PUBLIC HEARING MEMORANDUM

SUBJECT: **Petition #299-21**, SPECIAL PERMIT/SITE PLAN APPROVAL to allow a retail marijuana establishment, to allow parking facility requirements to be met off-site, to waive the minimum driveway width requirement, to waive perimeter screening requirements, to waive lighting requirements and to waive the 25% façade transparency requirement at **131 Rumford Avenue**, Ward 4, Auburndale, on land known as Section 41 Block 31 Lot 50, containing approximately 20,443 sq. ft. of land in a district zoned BUSINESS USE 2. Ref: Sec. 7.3.3, 7.4, 6.10.3.D, 4.4.1, 5.1.6.A, 5.1.6.B, 5.1.8.D.1, 5.1.13, 5.1.9.A, 5.1.10, 6.10.3.E.15 of the City of Newton Rev Zoning Ord, 2017.

131 Rumford Avenue

Site plan

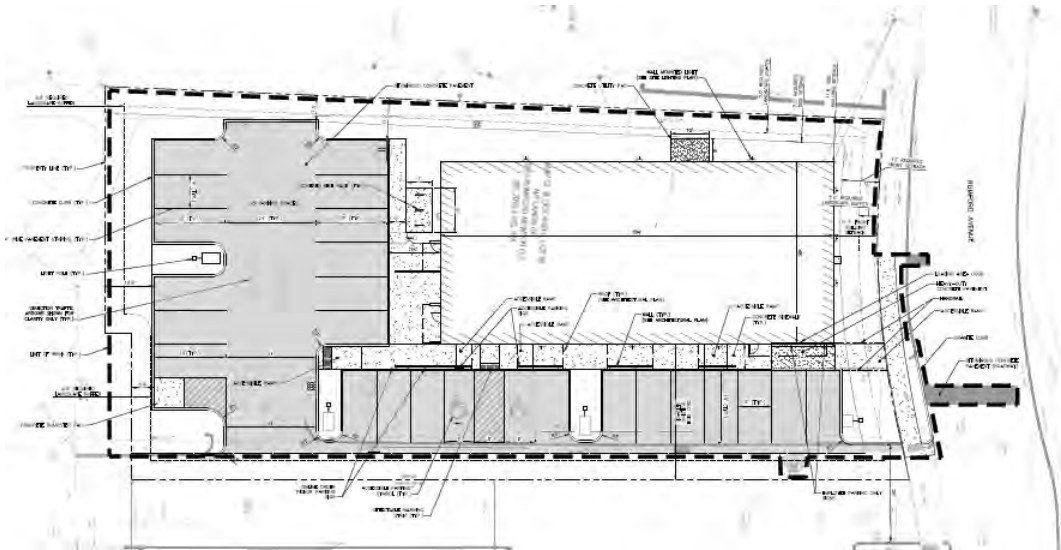
The proposed marijuana retailer's entrance would not be on Rumford Avenue, but rather at the rear of the building. This entrance would be reached by drivers via a driveway along the left (east) side of the property. While that driveway would be approximately 23 feet wide, most of its width would be located on the property that abuts to that side. Pedestrians would reach the entrance via a walkway located between the building and the head-on parking stalls located on that side.

As referenced above, vehicular access to the lot would be provided by a 23-foot-wide, two-way driveway that is located along the left (east) side of the property, but the width of which is mostly located on the adjacent parcel. Thirteen spaces, including two accessible stalls, would be accessed directly from that driveway (and the property upon which it is mostly located). The 12 spaces at the rear of the property would also be accessed by that driveway, but would do so by a shared two-way maneuverability aisle on the subject property. As such, all access and egress on/off the property would occur on that abutting property. The petitioner should prepare to discuss and/or provide documentation as to its continuing legal rights to so use the adjacent property.

Based upon submitted plans, the petitioners propose to install approximately 16 trees in various locations on the property and, additionally, 59 arborvitae along most of the length of the right-side property line. The parking stalls proposed for the left property line lack perimeter screening as they are located directly along that boundary and accessed via the adjacent driveway shared with the abutting

property, leaving no opportunity for any screening or landscaping there. The petitioner should clarify whether any fencing is planned for the site.

Rumford Ave.- front elevation

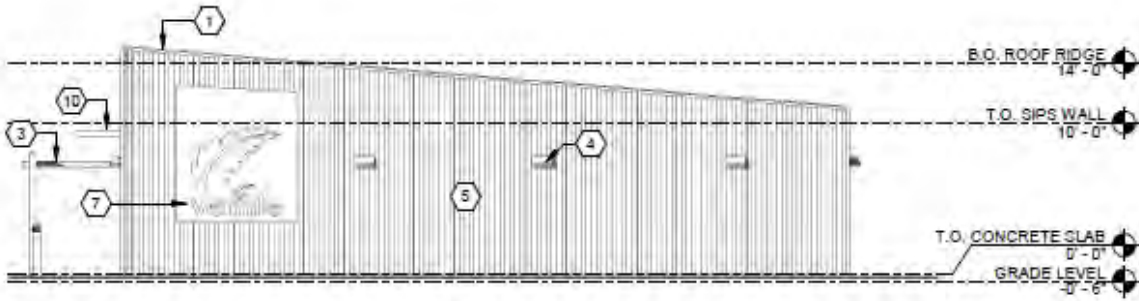
“located on the ground level shall provide at least 25 percent transparency along the building’s front façade at ground level, unless waived by the City Council.” The intent of this requirement is to ensure the security requirements found in the State Law do not overburden the aesthetics of the structure in relationship to the adjacent structures. The petitioner is proposing no transparent glass along Rumford Avenue as no customer spaces or entrance are located on that side.
